MEMORANDUM FOR : Chief, WCPO

SUBJECT :

After testing the Advanced 918 Light Table Prototype and reviewing the specifications, we arrived at the following list of items to be modified or repaired.

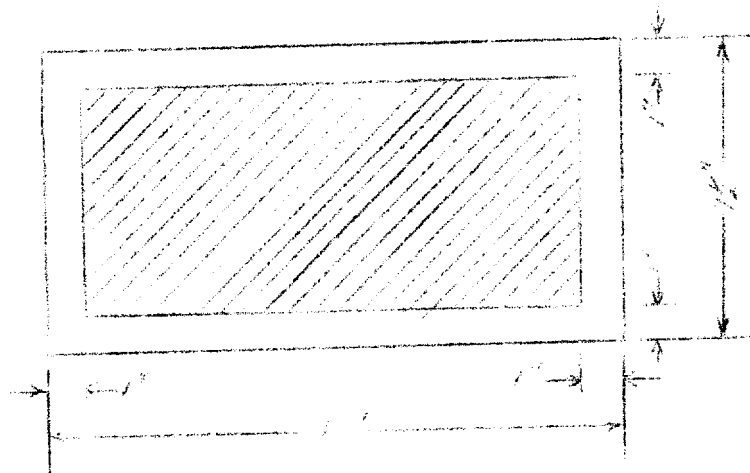
g. The illumination system must provide a maximum illumination of at least 2,000 ft. lamberts within a 2" radius of the geometric center of the illuminated area. The maximum linear brightness gradient must not exceed 15% between any two measurements taken within the shaded area shown on the diagram below, nor 25% anywhere within the illuminated area.
